**NOTICE OF PROPOSED CHANGE IN PROPERTY**

Petition: x867 R.A

**GLWA GPET 19-040: REVx867A**

# REQUEST TO OUTRIGHT VACATE THE FOLLOWING PUBLIC RIGHT OF WAYS :  
 - CONNER LANE FROM MACK AVE. TO ITS NORTHERN TERMINUS.  
 - CANAL STREET FROM FREUD AVE. TO ITS SOUTHERN TERMINUS.  
 - EAST/WEST ALLEY SOUTH OF MACK AVE. AND WEST OF ST. JEAN.  
 - REMAINING 50 FEET OF THE EAST/WEST ALLEY NORTH OF KERCHEVAL AND WEST OF ST. JEAN.  
 - THE FIRST NORTH/SOUTH ALLEY WEST OF ST. JEAN FROM THE SOUTH LINE OF E. VERNOR HWY. ST. TO THE SOUTH LINE OF 2130 BENITEAU ST.

DETAIL -A-

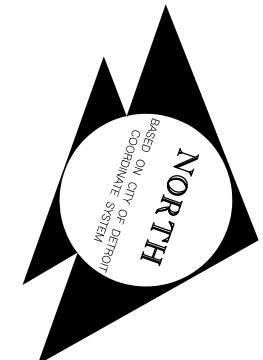
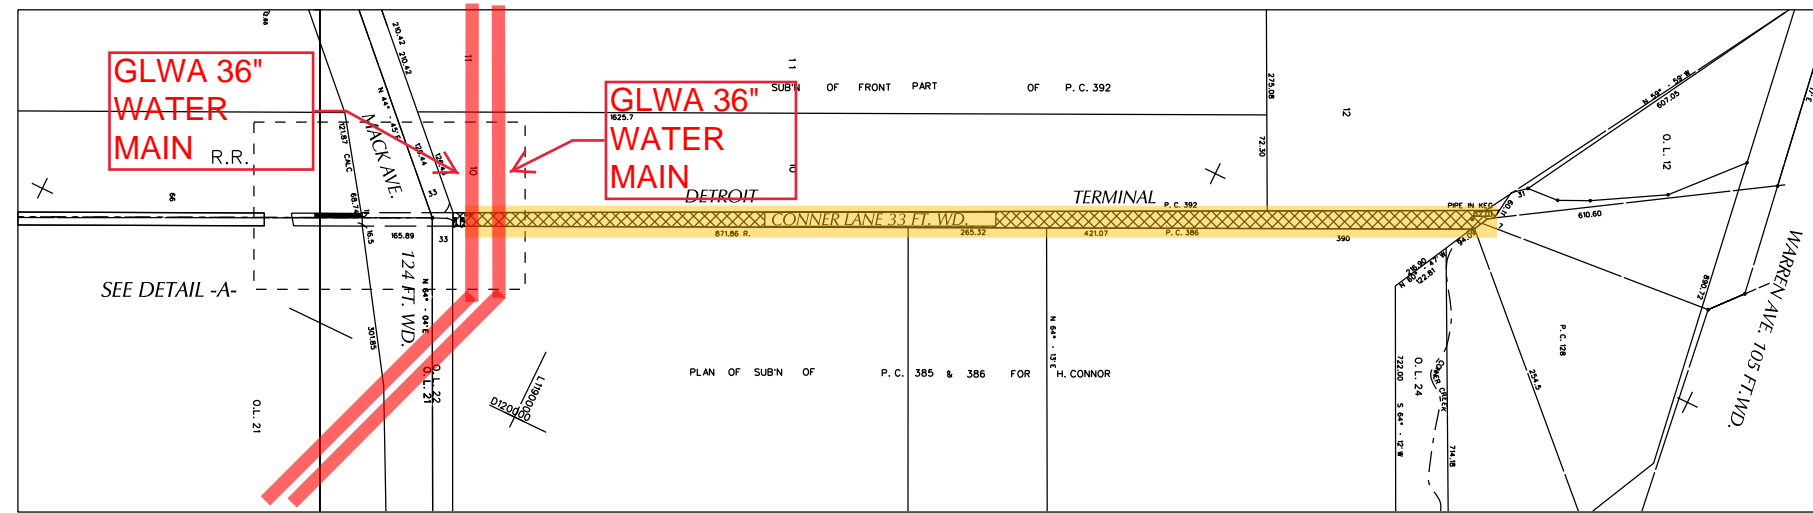
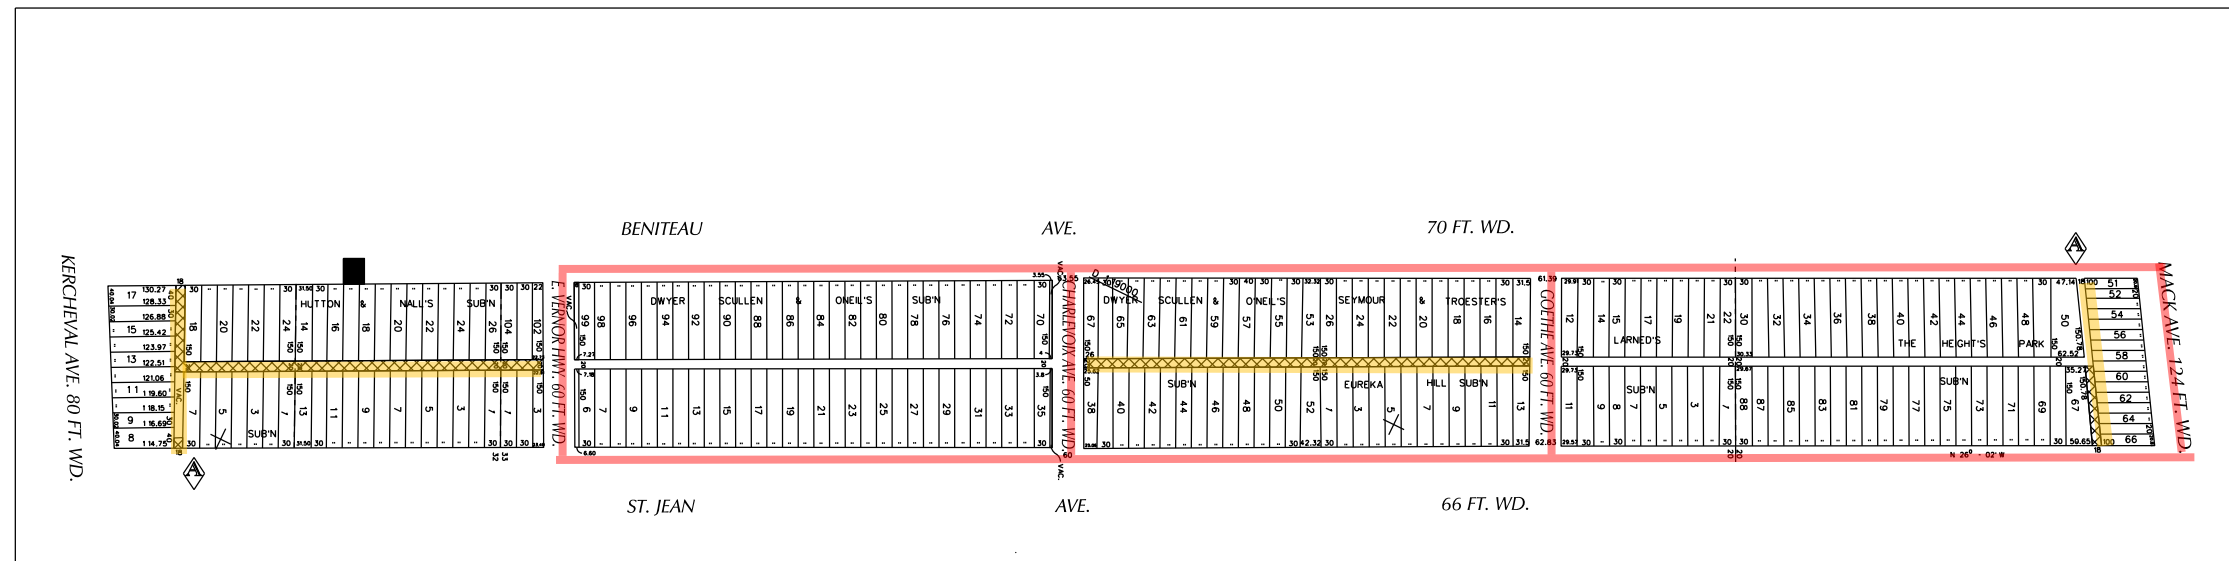
GLWA has two (2) 36" water mains on Mack Avenue, a CSO Facility at Conner Creek with entrance through Canal Street and a Sewer Main at Conner Creek CSO as shown above.
